Reference no	PLN-25-0181
Site	LOT 2, 63 CATHERINE STREET LONGFORD
Proposed Development	Multiple Dwellings for Assisted Living (3 x new) (Vary Density, Longford SAP)
Zone	8.0 General Residential
Use class	Residential

RE: Additional Information Required for Planning Application PLN-25-0100 Multiple Dwellings x 3 (Longford SAP) at 63 Catherine Street, Longford

# **Proposed Muliple Assisted Living Dwellings**

# 63 Catherine St Longford Tas 7301 Client: BP Property (Tas) Pty Ltd

A02-DA07

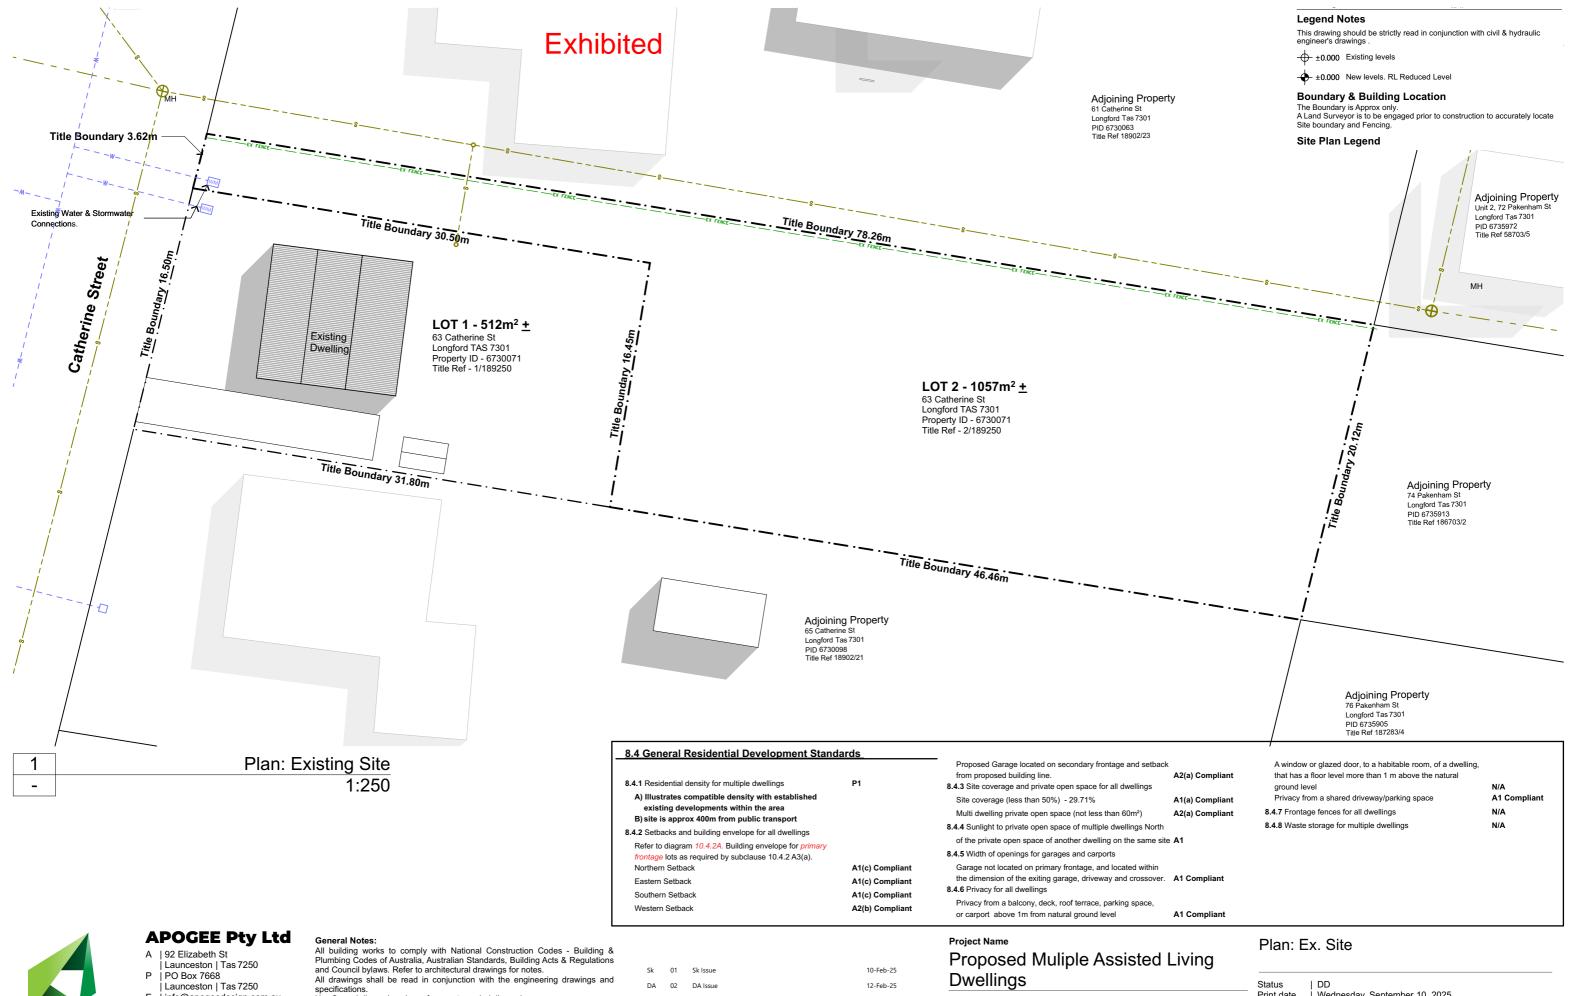
1. Revise the title boundaries shown on the site plans as these don't reflect the folio plan. If the title boundaries shown are meant as future strata boundaries, please clarify this on the plans.

Response: Refer attached Plan of Survey undergoing planning and Land titles process

A03-DA07

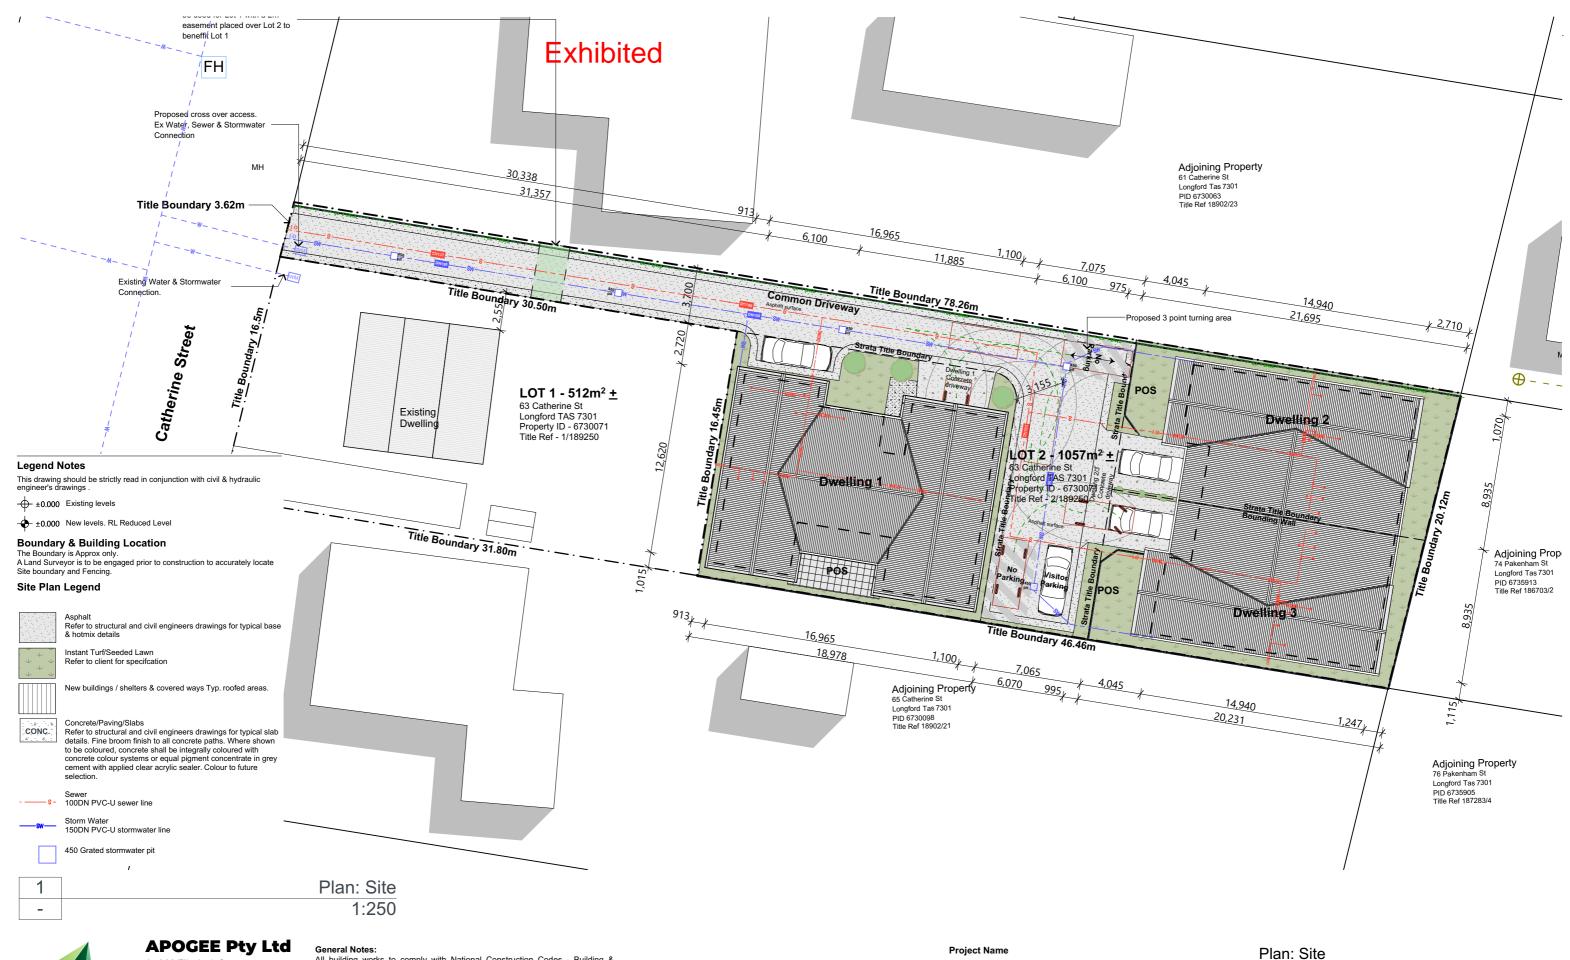
3. Review dimensions shown on drawing A03 for boundary lengths and setbacks and amend as required. When scaled, the dimension of title boundary shown at 54.4.m should be 46.46 as shown on A02-DA03.

4. Revise the setbacks dimensions on A03-DA03. For instance, the southern side boundary setback measurement shown is not in line with the building line shown.

7. Plan A03-DA03 shows "proposed" service connection for water etc. The LIST map shows that there is an existing water connection in that location and sewer connection to the north. Please review and revise this comment on the plan to clarify what works are proposed.

Response: Refer amended plans

Response: Revised, Refer amended plans

Response: Refer attached Plan of Survey

## Shadow diagrams

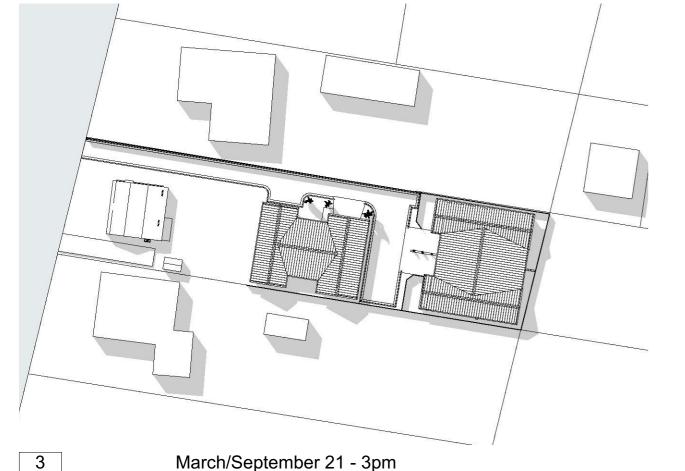
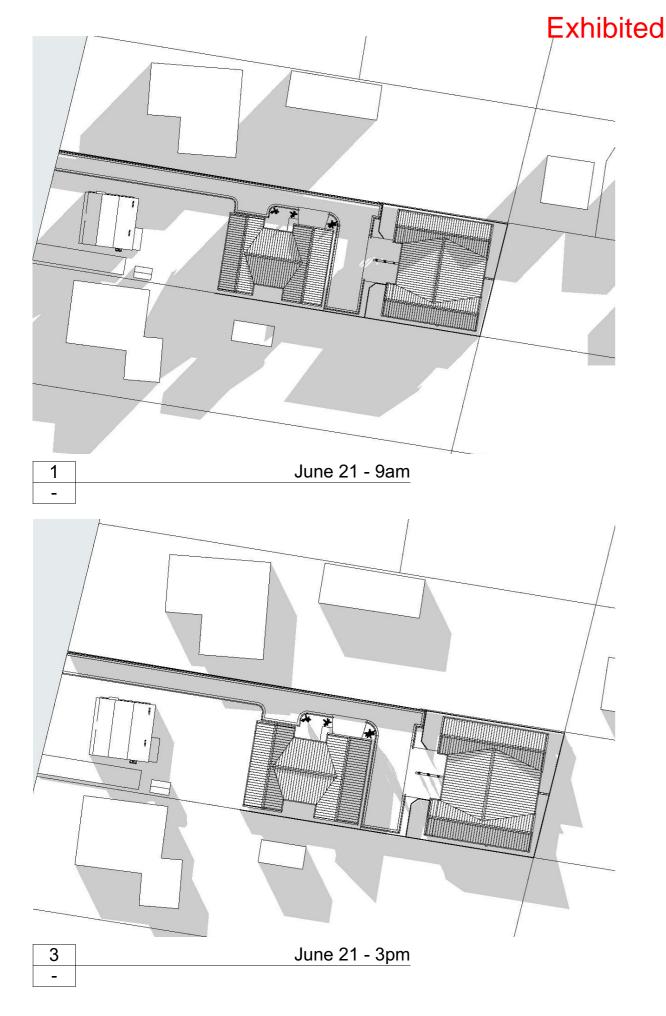
6. Provide shadow diagrams for the proposed development so consideration can be given to any impacts (per clause 8.4.2 P3).

Response: Revised, Refer amended plans
